SERVICE INSTRUCTION FUEL PRESSURE INDICATION PROBLEMS ON ROTAX_® ENGINE TYPE 912 (SERIES) SI-912-008

FEBRUARY 2002 Rev.1

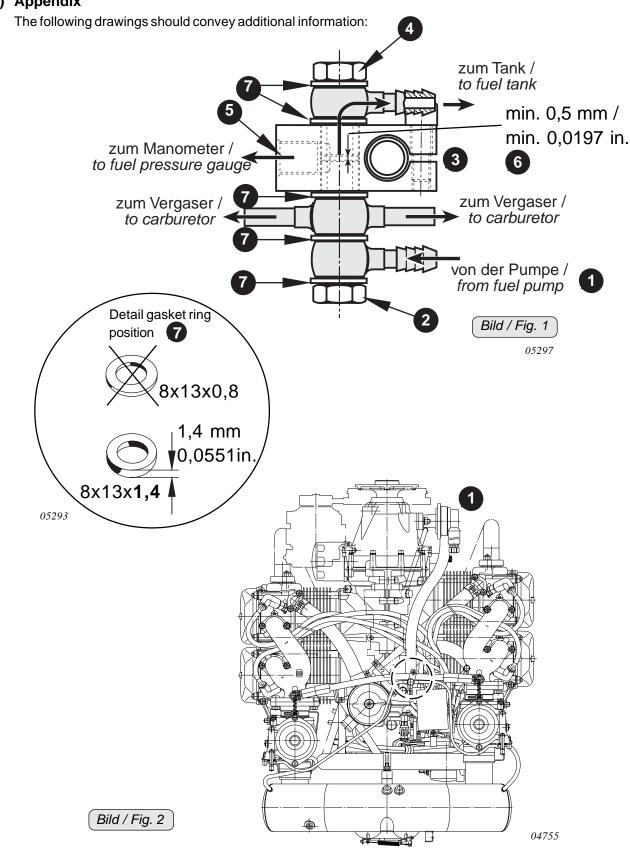
The fuel passes from the fuel pump (1) via the banjo bolt (2 & 4) to the carburetors. Fuel is allowed to enter the clamp block (3) through the gap (6) present between the two banjo bolts and pressurize the outlet port (5) for delivery to a customer supplied fuel pressure indication system. Reduced tolerances of the assembled components could result in the gap (6) becoming closed or too small to allow fuel pressure into the manifold block at port (5). This could result in intermittent or complete malfunction of the customer installed fuel pressure indication system.

By virtue of design, fuel would continue to pass from one banjo bolt (2) to the other banjo bolt (4) thereby having no affect on the supply of fuel to the carburetors.

In all cases a gap (6) of at least 0,5 mm (0,0197 in.) must remain between the banjo bolts.

If inspection of the components to ensure conditions listed in section 1.3 do not exist and the gap is still below the minimum so all gasket rings (8/13/0,8) are to be renewed by the gasket rings PNo. 950143 (8,2/13/1,4).
